River Mile 10.9 Removal Action – High Sub-grade Cap Design

PREPARED FOR: de maximis, inc.
COPY TO: File
PREPARED BY: CH2M HILL
DATE: September 26, 2013
PROJECT NUMBER: 474468.RA.PM.01

This technical memorandum presents a revised cap cross-section design for RM 10.9 near shore areas where high sub-grade prevents excavating 2 feet of sediment prior to placing the cap.

Figure 1.
Typical Cap Section for High Sub-Grade Areas
Lower Passaic River Study Area, New Jersey

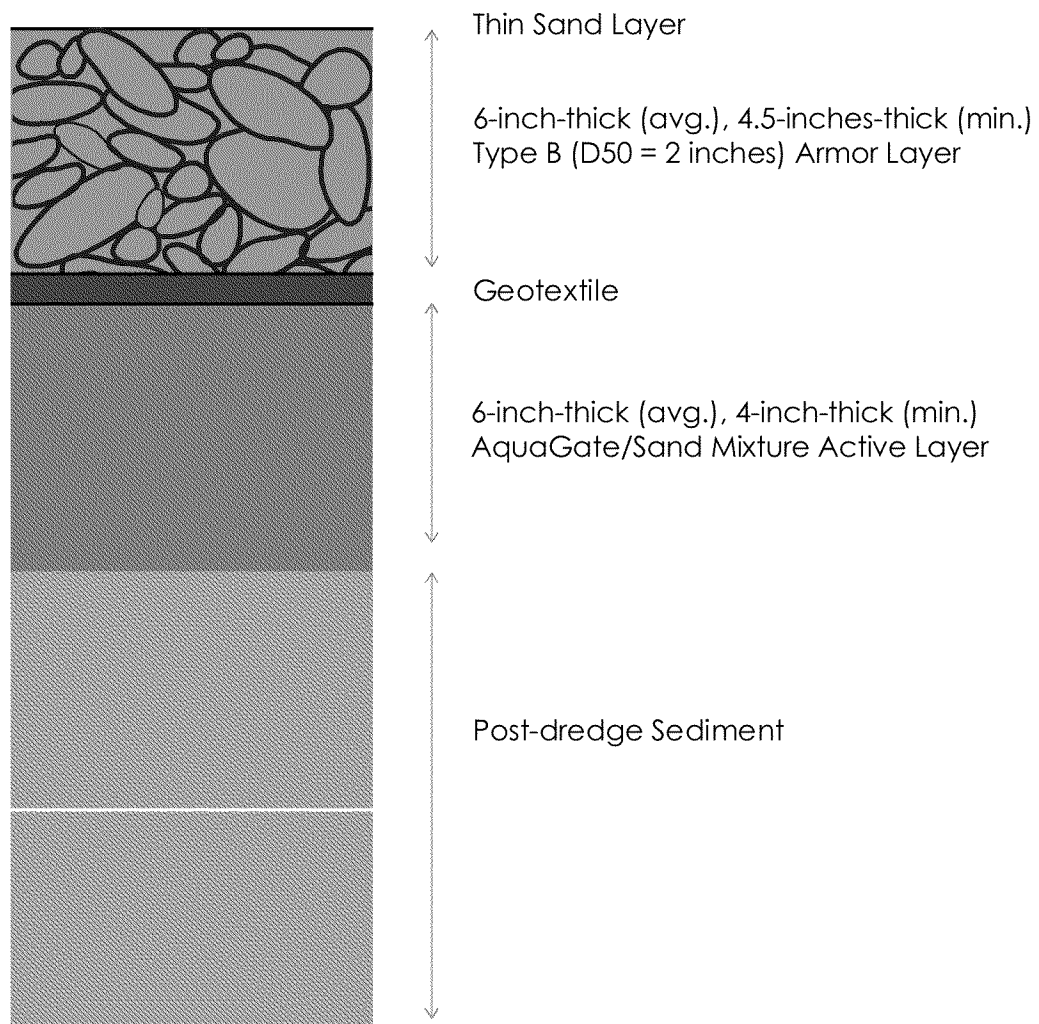
A revised cap design was developed for placement in high sub-grade areas where at least 1.75 feet of sediment cannot be excavated prior to placing the cap. It is assumed for purposes of this design that residual contaminated sediment would remain on top of the high sub-grade as the environmental bucket cannot fully remove all sediment on top of this hard material. The revised cap would be placed to isolate this residual contaminated sediment. The revised cap design (see Figure 1) consists of an average of 6 inches or more of active material (i.e., the same AquaGate and sand mixture as the standard RM 10.9 cap design), geotextile, 6 inches of Type B ($D_{50} = 2$ inches) armor stone, and a thin layer of sand just covering the top of the armor stone. Based on results from the CapSim analysis, the revised cap cross-section will still be fully protective for those conditions in near shore areas (i.e., water depths less than 3-feet-deep) with a high sub-grade.

12-inch-thick Type A armor stone layer, an armor layer utilizing Type B armor stone may be substituted. The average Type B armor stone layer thickness should be 6 inches with a minimum of 4.5 inches.

The active material/sand mixture thickness should be varied so that top elevation of armor layer is no greater than the original sediment elevation. The active material/sand mixture thickness shall be maximized; however, the active material/sand mixture is not required to exceed the minimum 8-inch thickness specification required for all other capped portions of the Removal Area; in the high sub-grade areas, a minimum of 4 inches will be required instead.

A revised cap cross-section design has been developed for placement in high sub-grade areas where 2 feet of sediment cannot be excavated prior to placing the cap. The revised cap cross-section design for the high sub-grade areas consists of a 6 inches of active material (i.e., the same AquaGate and sand mixture as the standard RM 10.9 cap design), geotextile, 6 inches of Type B ($D_{50} = 2$ inches) armor stone, and a thin layer of sand just covering the top of the armor stone. The revised cap cross-section will still be fully protective for those conditions in near shore areas (i.e., water depths less than 3-feet-deep) with a high sub-grade.
